SERVICE INFORMATION

Number: 551-1579

Binding handbrake lever

Saab 900 M94-

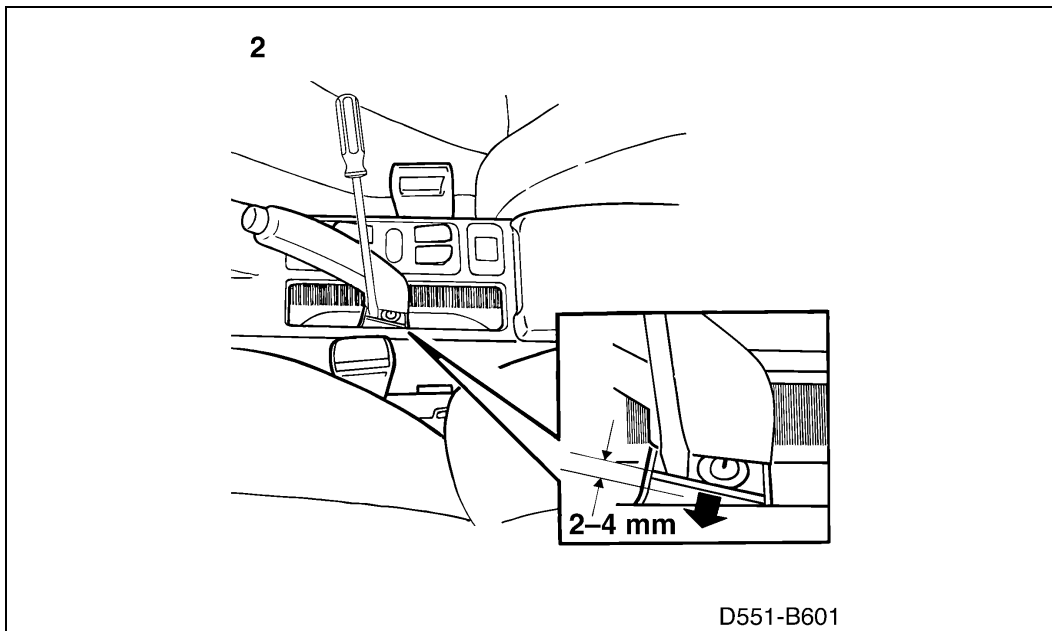
On some cars the handbrake release button may stick in the depressed position on releasing a handbrake lever that has been pulled on very hard. In the event of complaints from customers, the following procedure may be adopted.

- 1 Remove the left-hand brush in the cover by snapping it off its mounting.
- 2 Prise out the metal plate 2-4 mm so that it clears the cable/rod at its upper edge.
- 3 Refit the brush.
